CONSTRUCTION PLANS FOR

NOR ESTE MANOR SUBDIVISION

DRAINAGE, GRADING, PAVING AND UTILITY
IMPROVEMENTS

NOTE:
SHEETS AFFECTED BY CHANGE ORDER #1
AS INDICATED

DRAWING NO. 3355
MAP NO. C-19
SHEET 30 OF 52

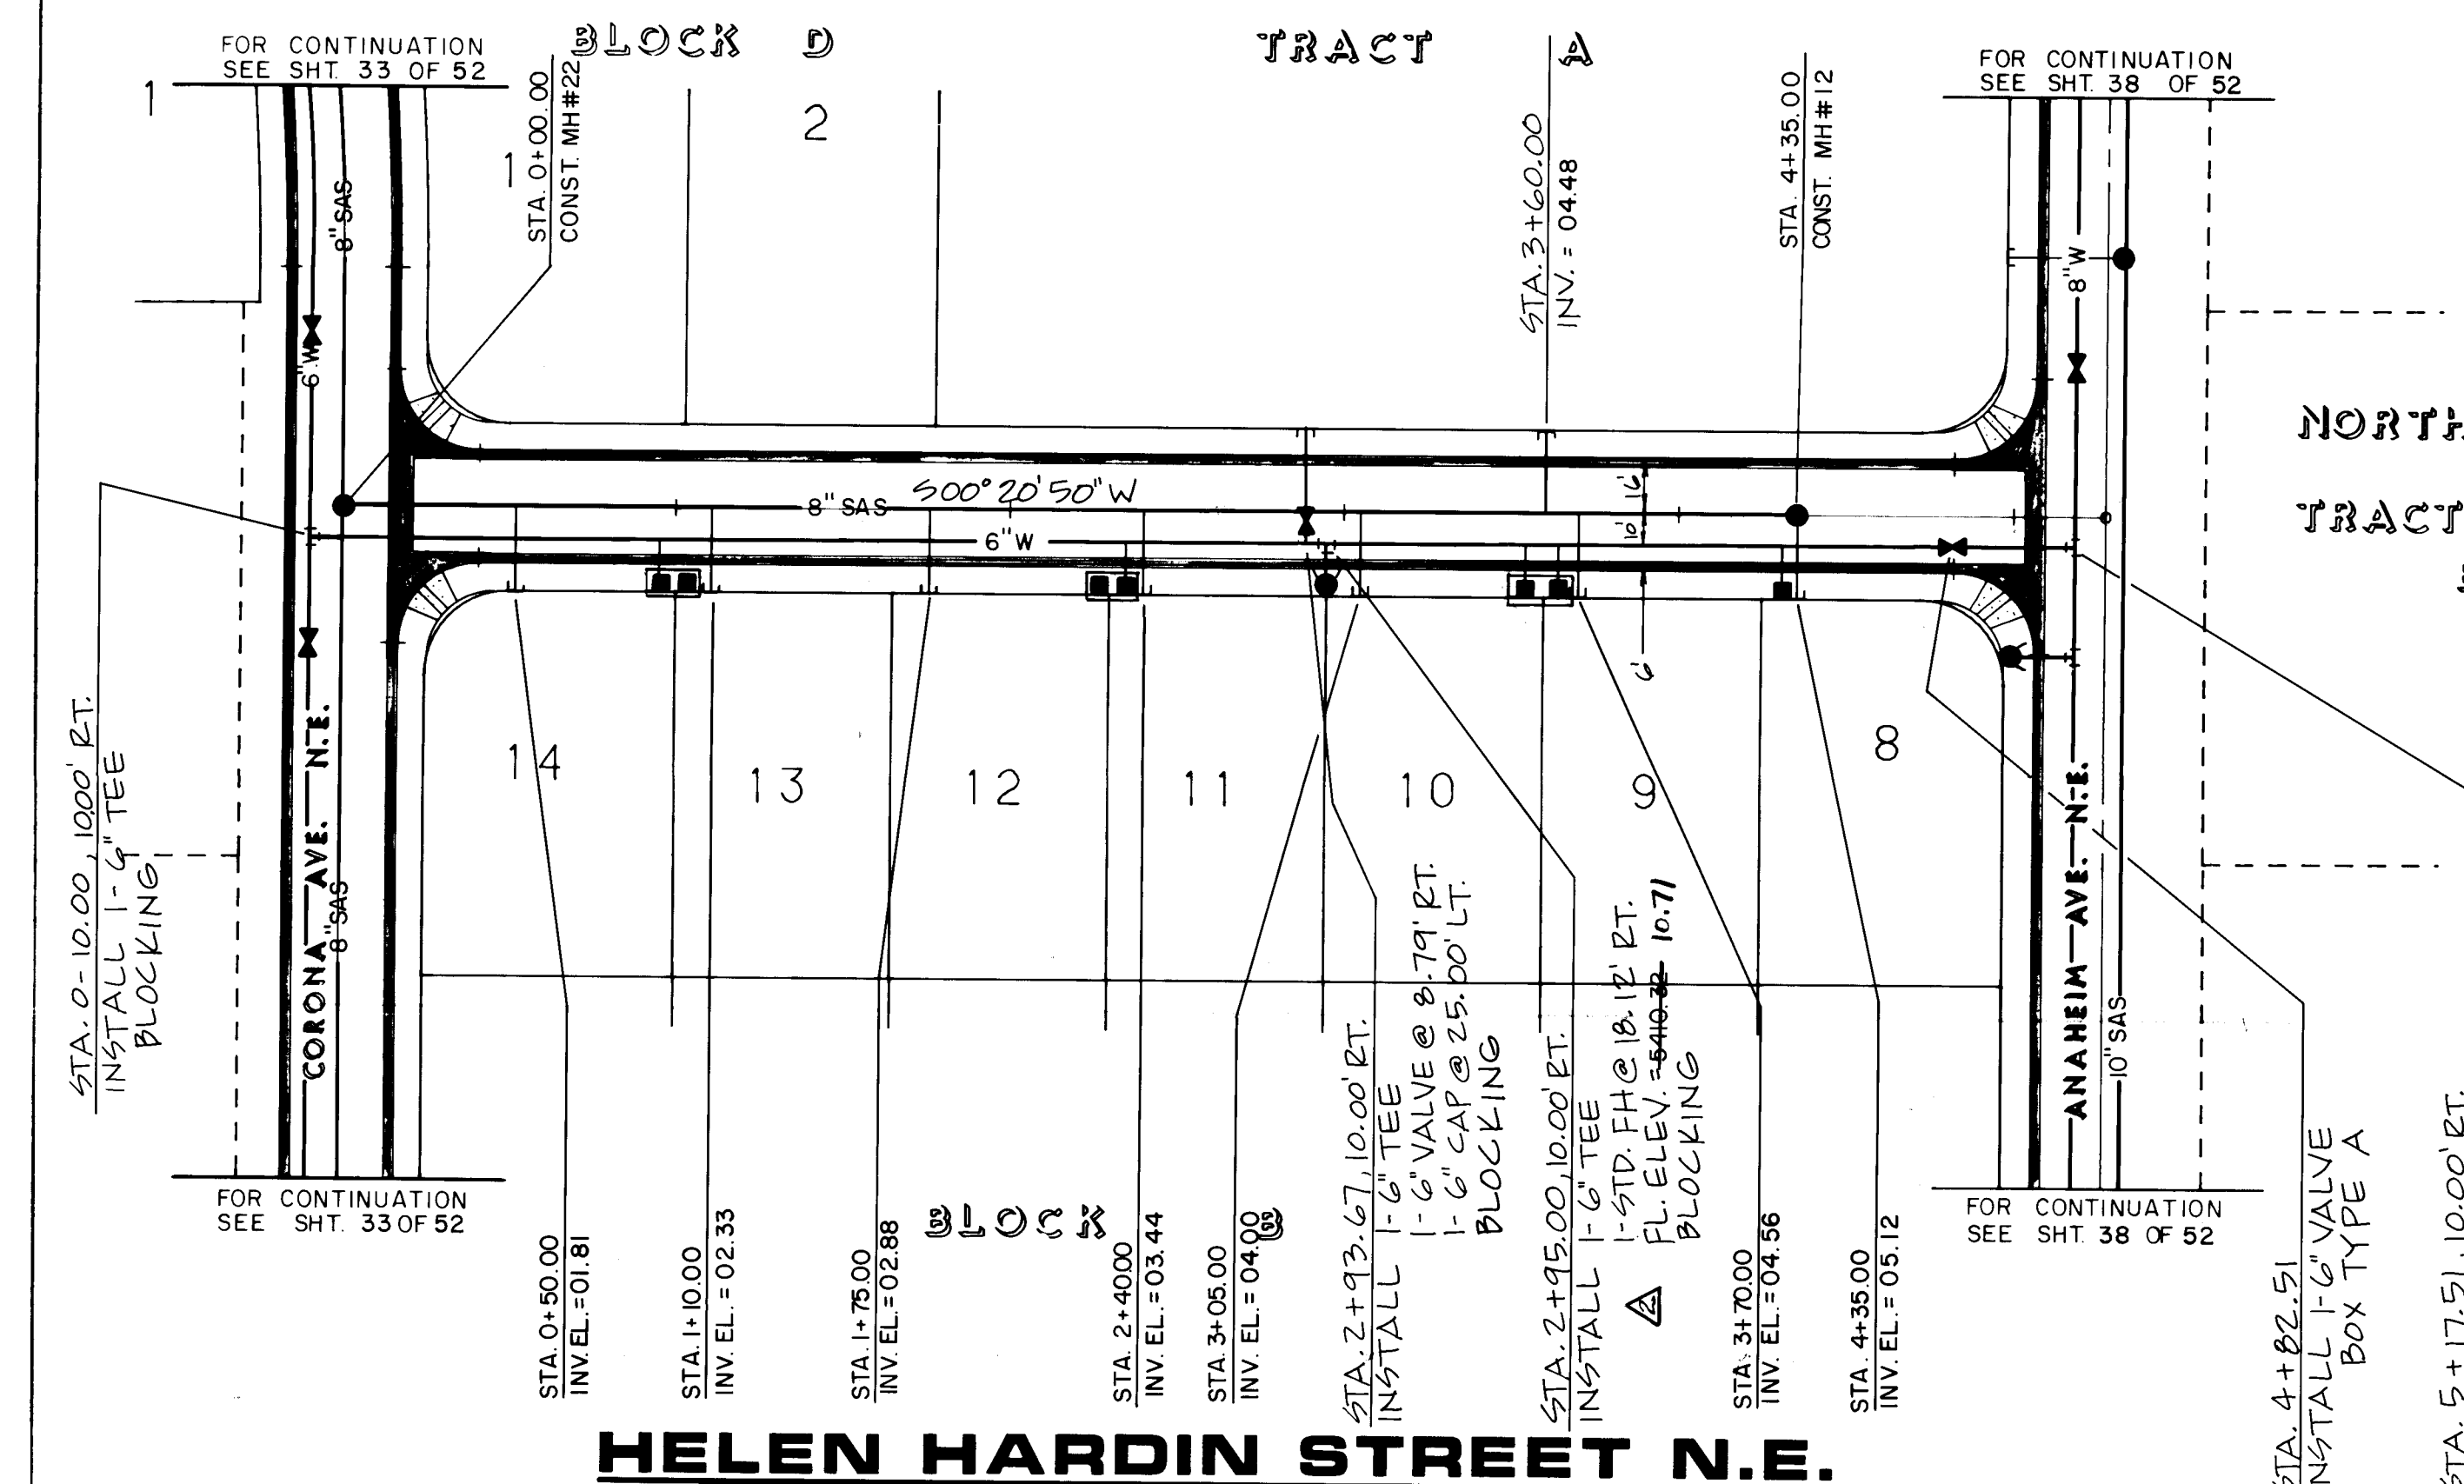
CHANGE ORDER No. 1
 REVISIONS
 REGRADE HELEN HARDIN AND CORONA SEWER/WATER

DRAWING NO. 3355		MAP NO. C-19 SHEET 31 OF 52

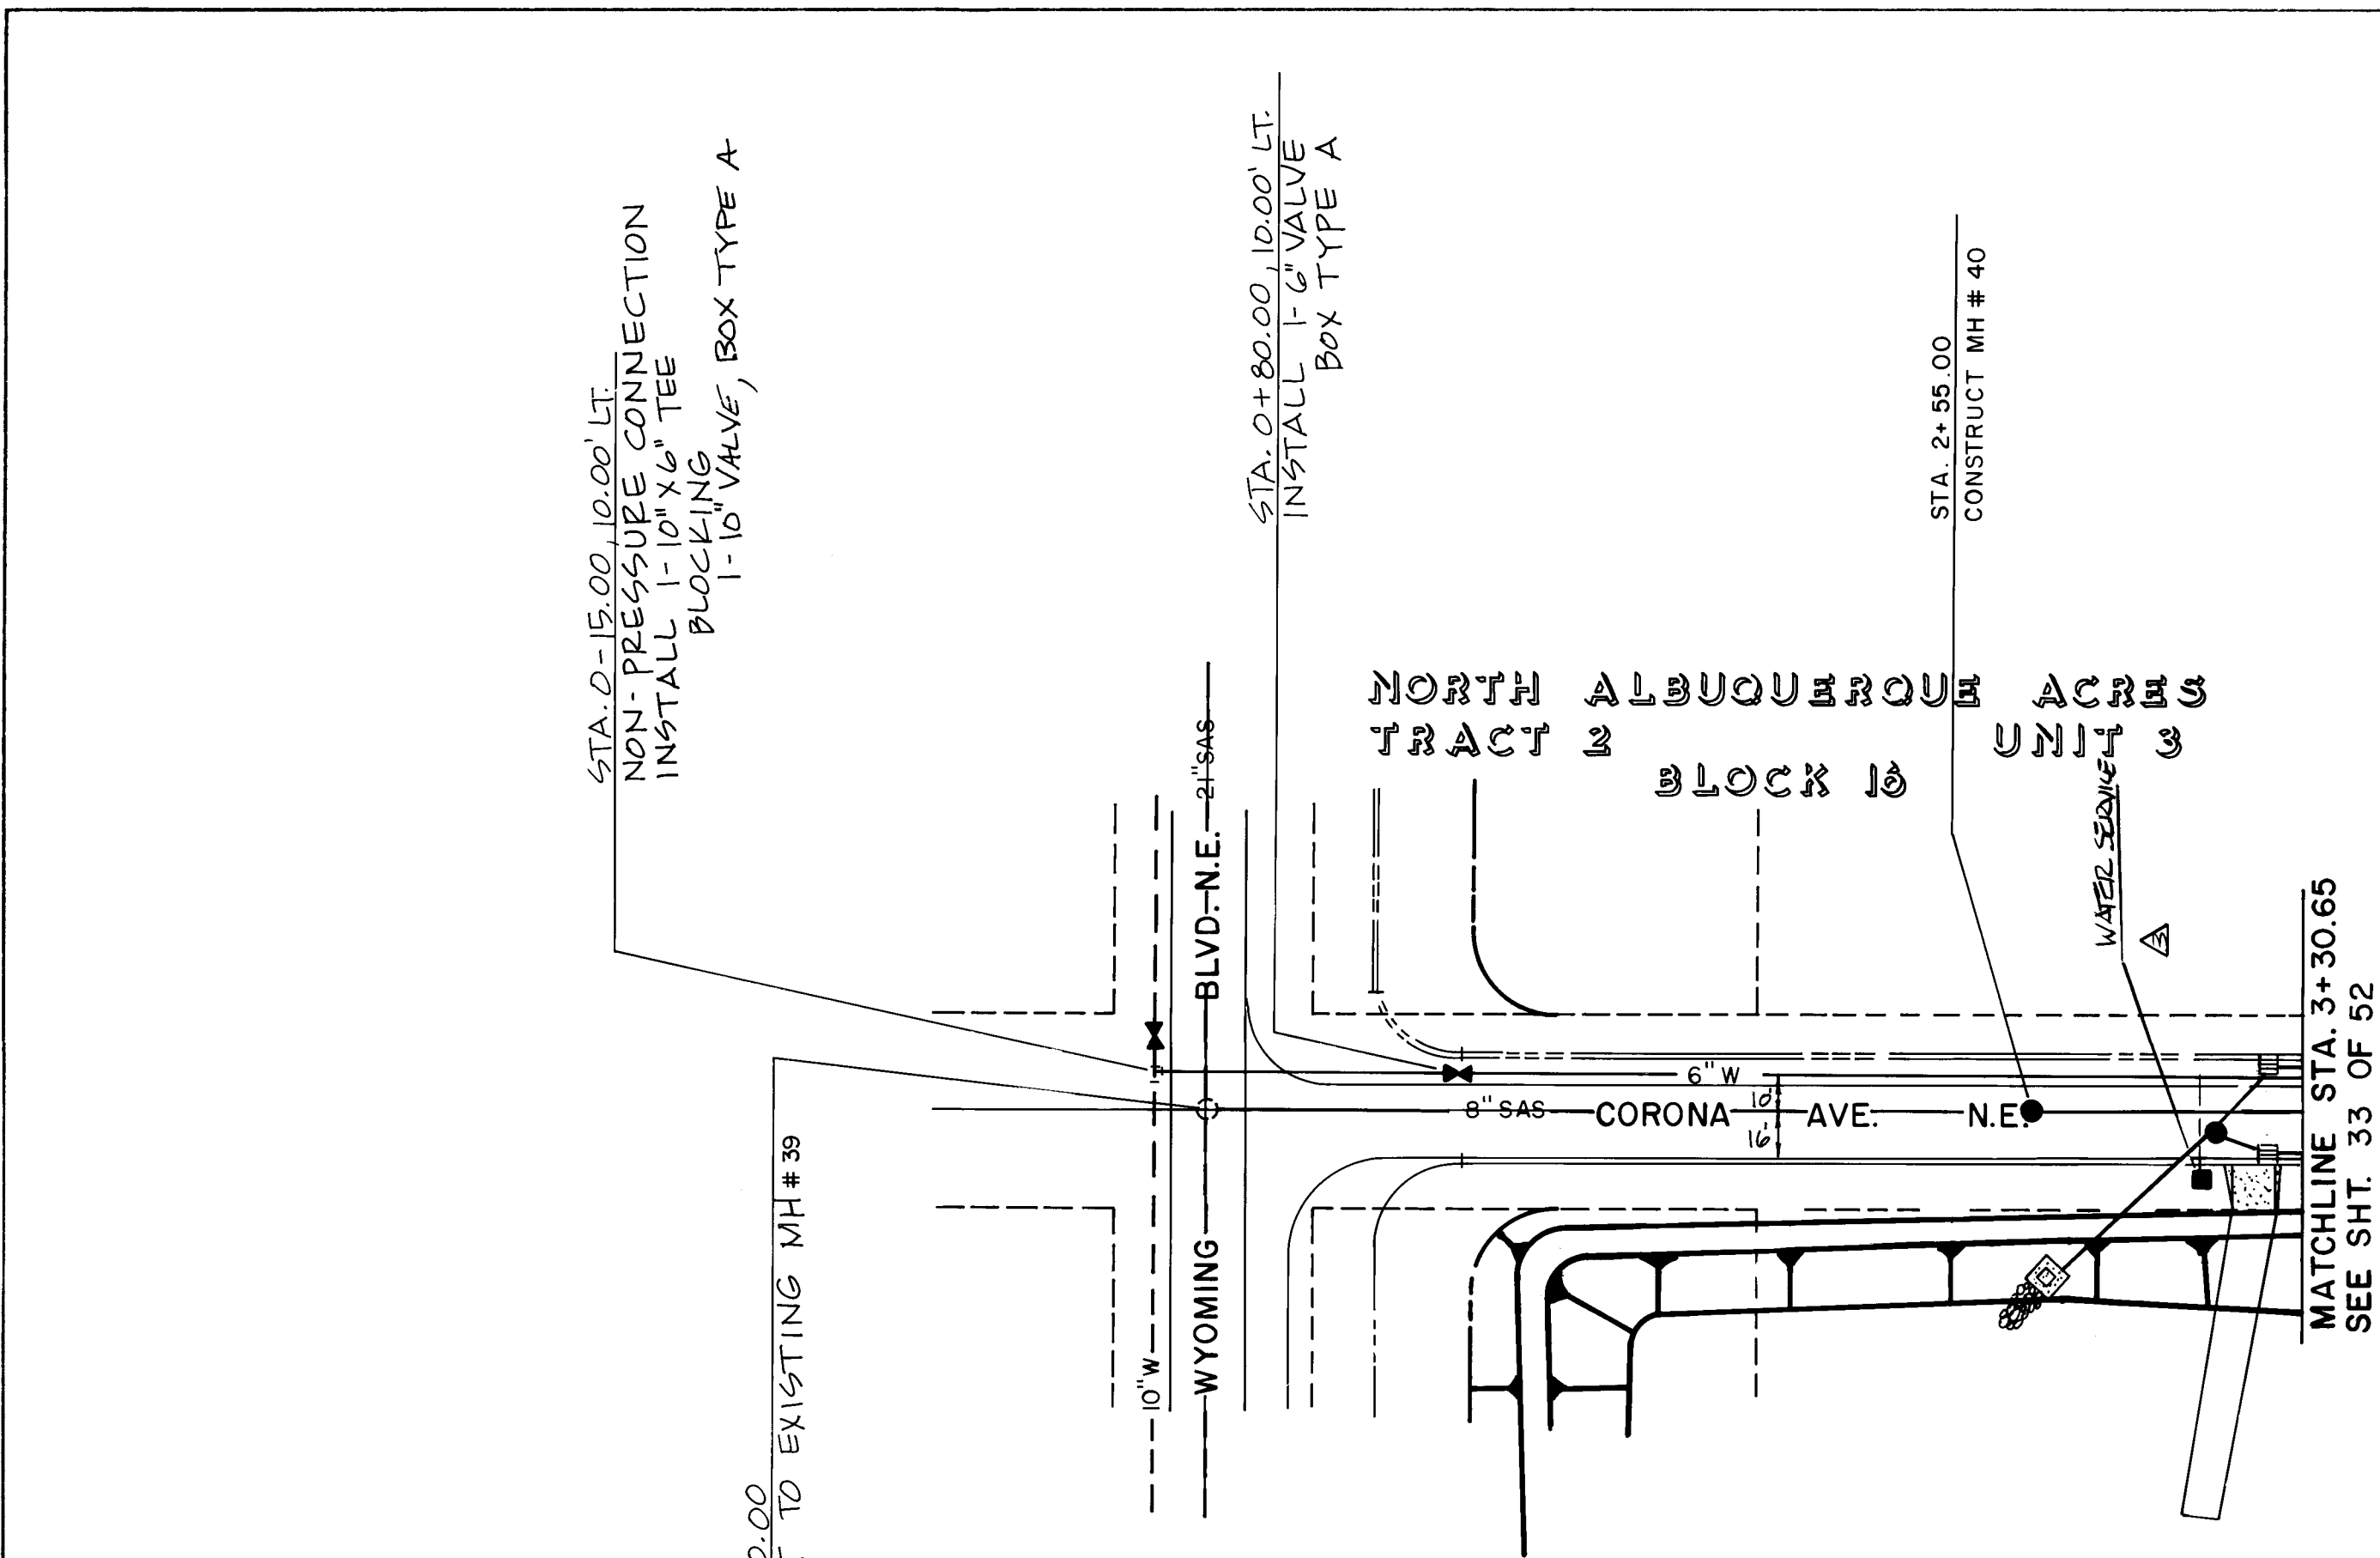
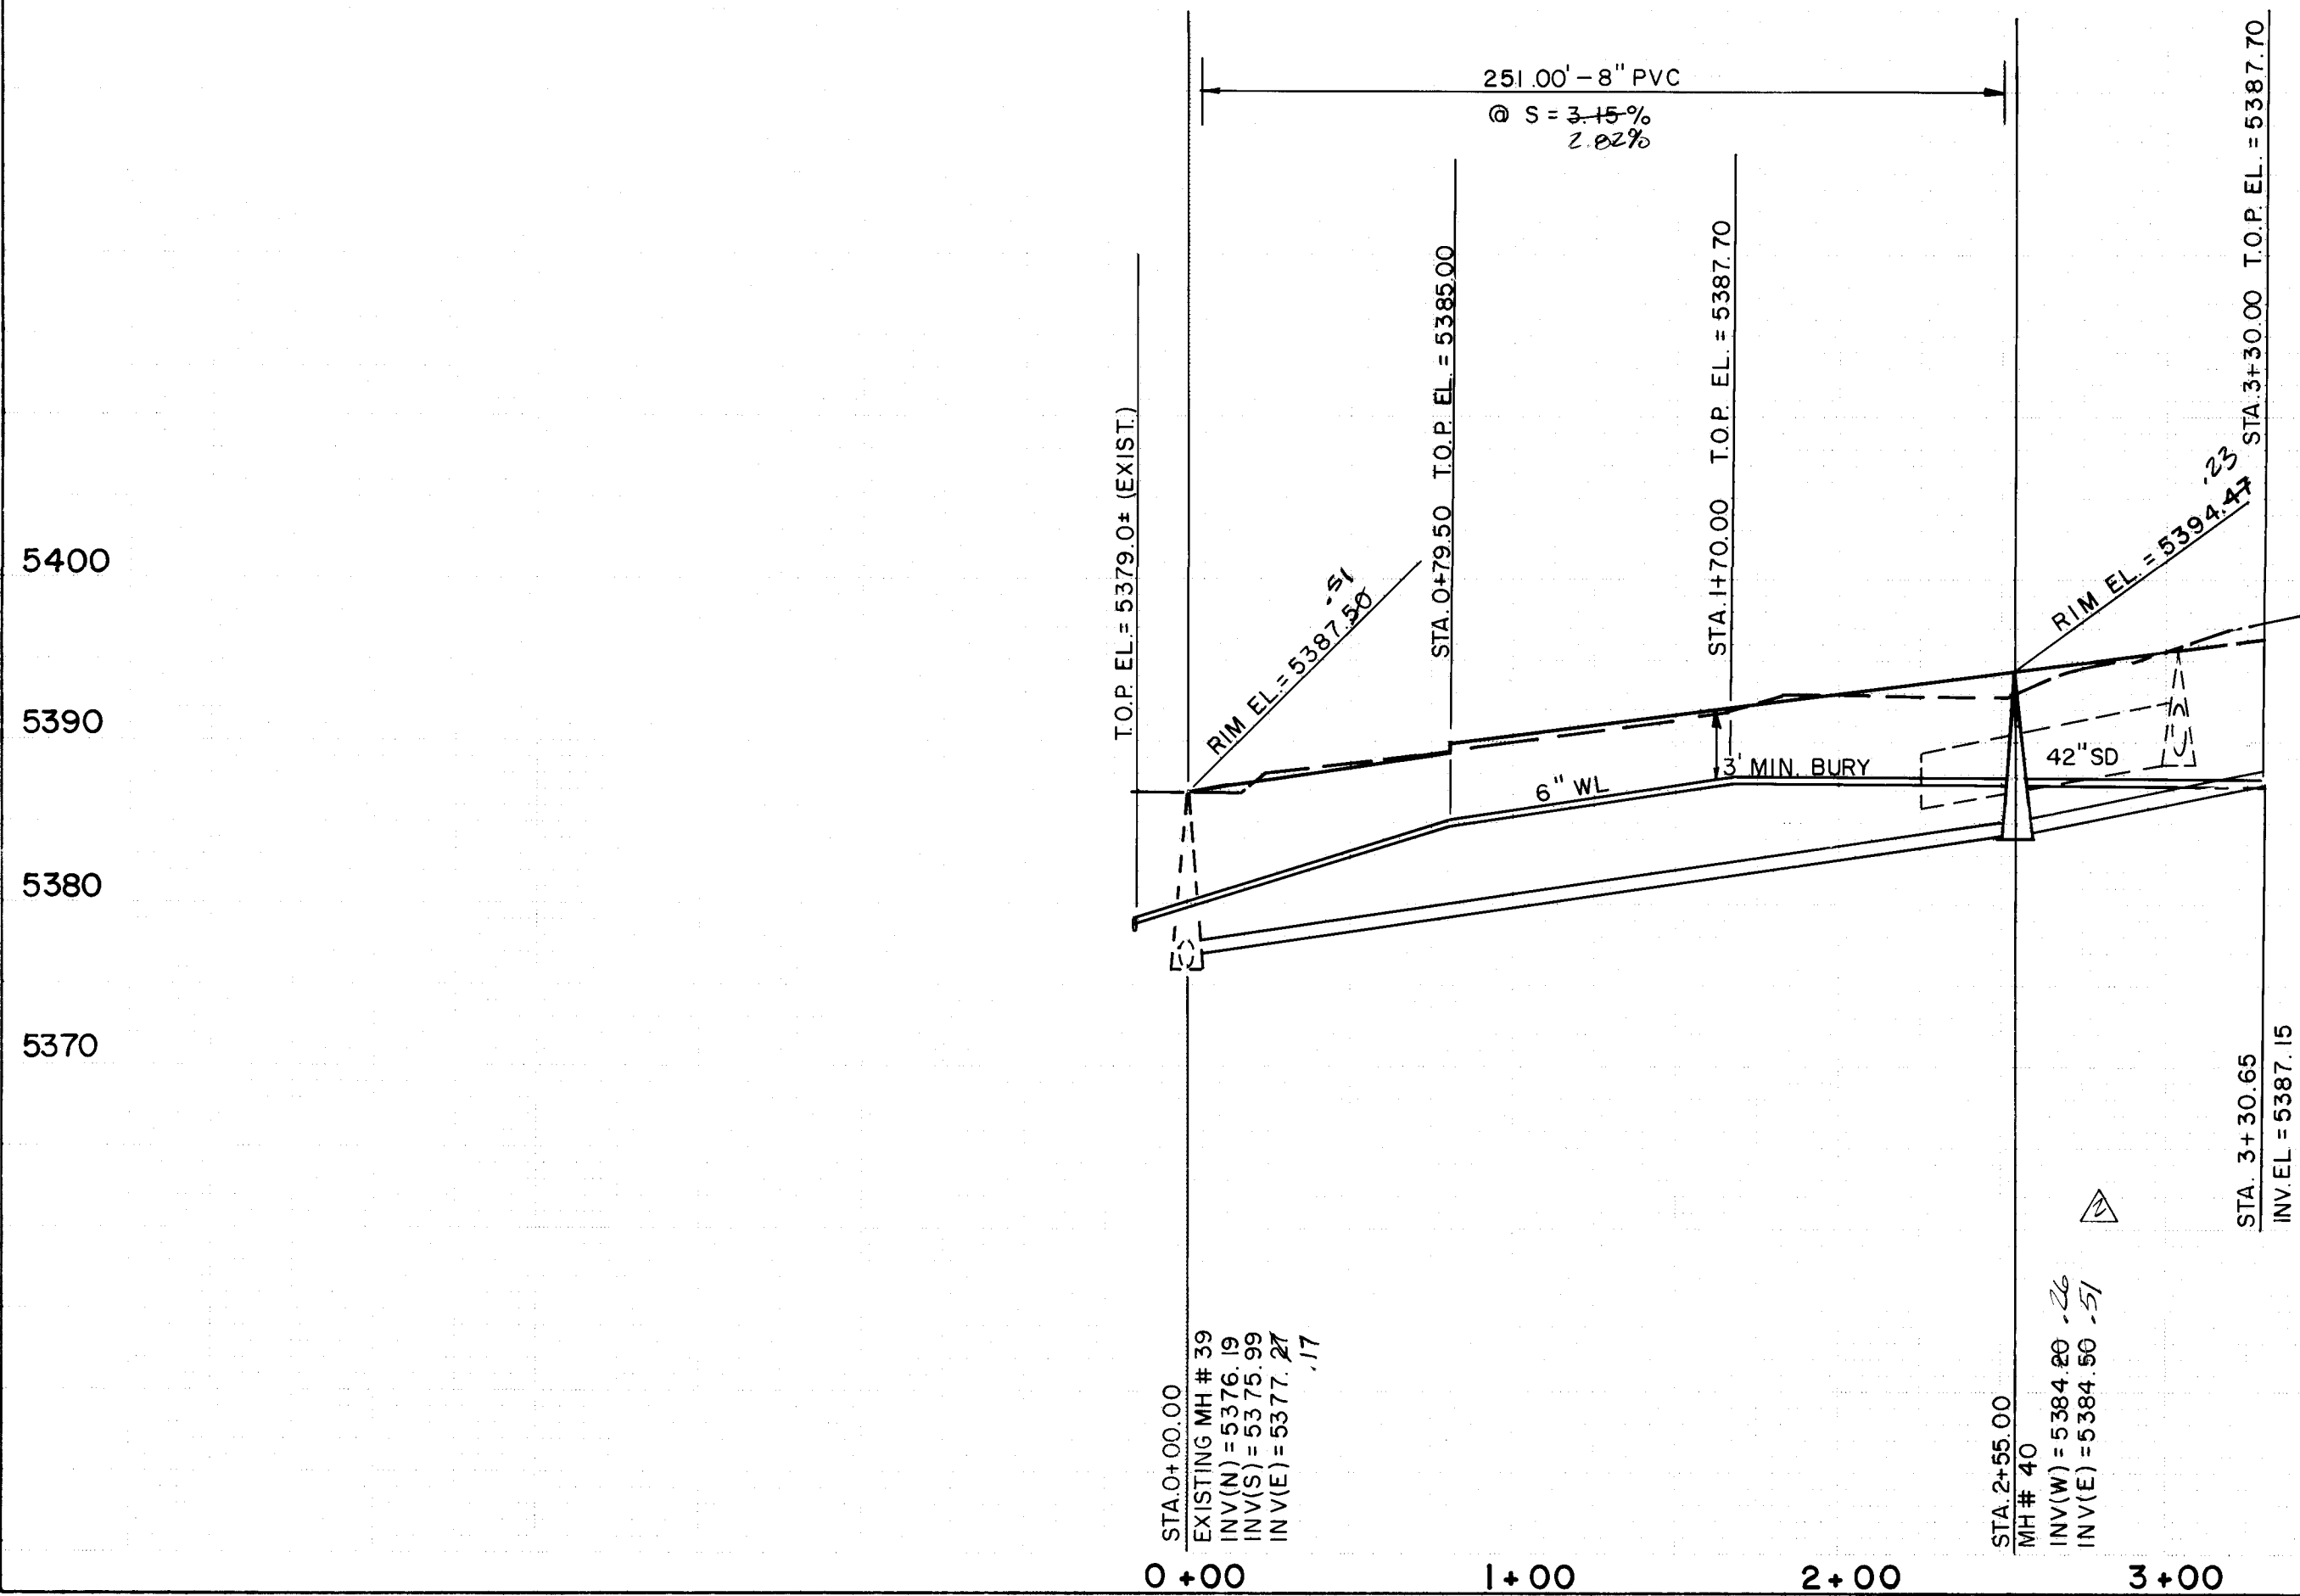
CHANGE ORDER No. 1
REVISIONS
REGRADE CORONA SEWER/WATER
